September 30, 2009  
NRC3-09-0014

Subject: Detroit Edison Company Response to NRC Requests for Additional Information Related to the Environmental Review

**Response to RAI letter related to Fermi 3 ER**

**Figure 5.8-1 Estimated Environmental Noise Emissions—A-Weighted Sound Pressure Level Contours (dB(A))—Resulting from Normal Operation (Fermi 3 Cooling Systems and Transformers)**

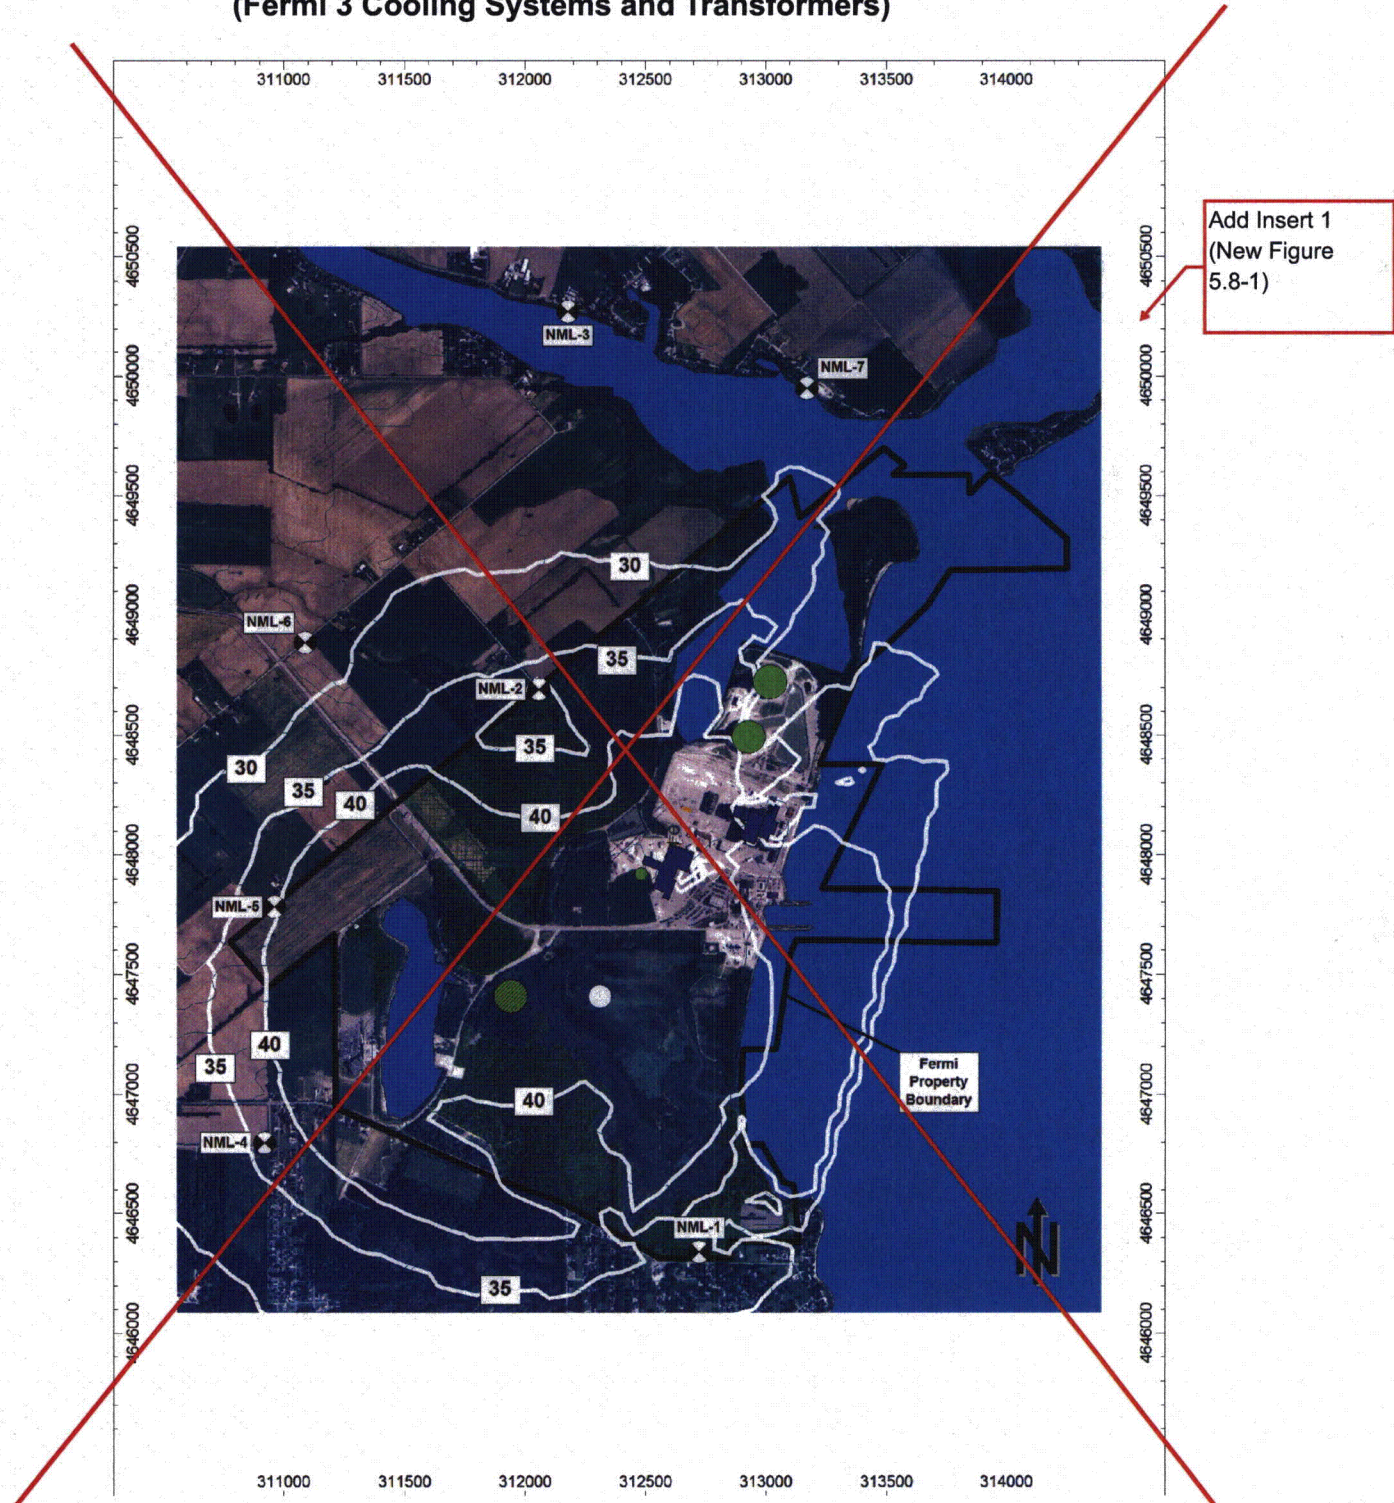
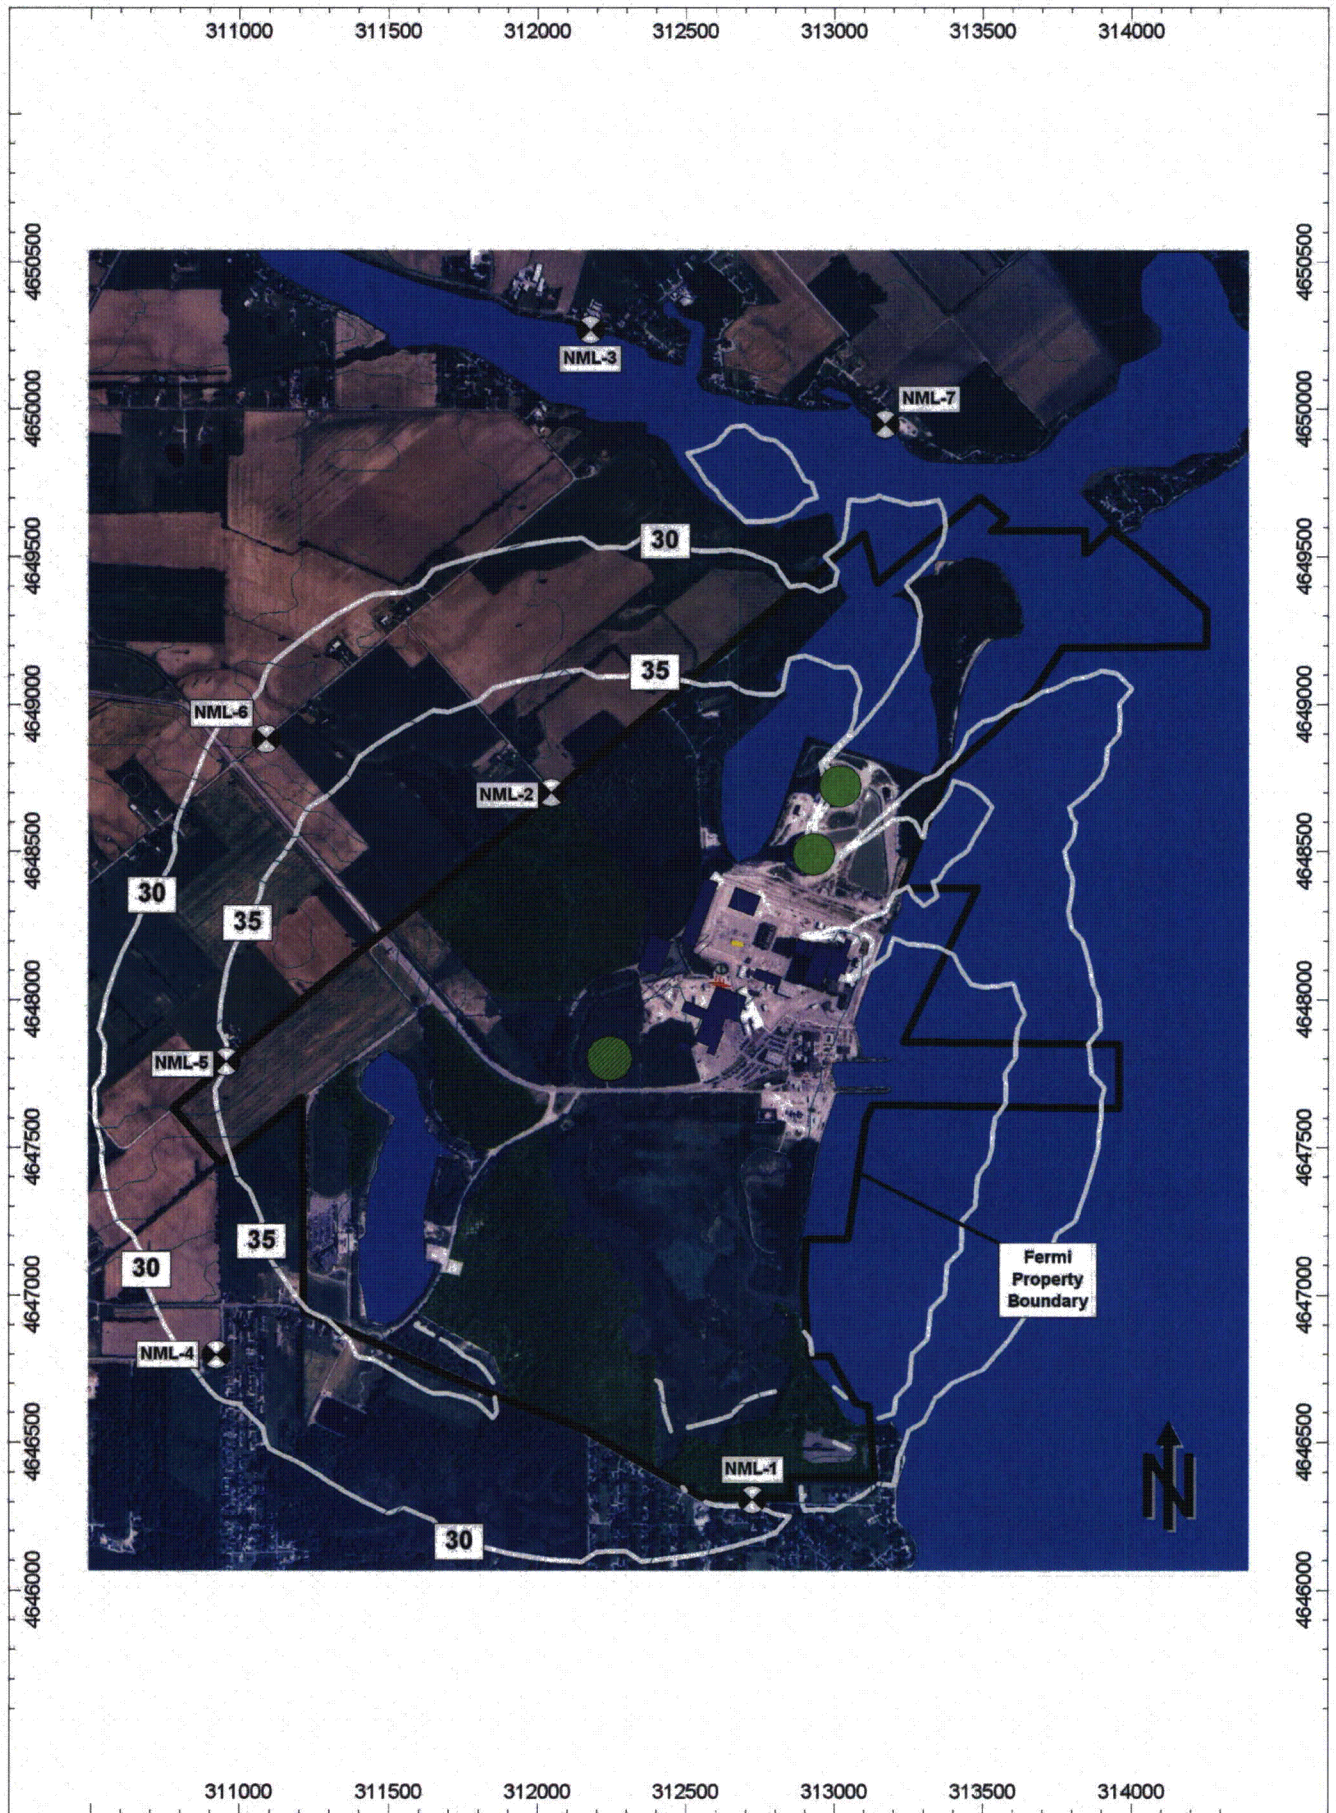
The updated acoustical model also resulted in changes to the predicted noise contours shown in the revised ER Figure 5.8-1. Additionally, the acoustical model was also updated so that noise levels within wooded areas of the Fermi site were not predicted. This update to the acoustical model is appropriate since its purpose is to predict the effect of the wooded areas on propagated facility noise, and not to predict the noise levels within the on-site wooded areas.

ER Section 5.8.1.3.4, Table 5.8-1 and Figure 5.8-1 will be revised as shown in the attached markup.

The estimated sound levels from normal station operation (Fermi 3 equipment only) are shown graphically on the noise contour plot of Figure 5.8-1. Sound levels at the nearest noise sensitive receptors (see Subsection 2.5.5) resulting from normal station operation are provided in Table 5.8-1 and Table 5.8-2.
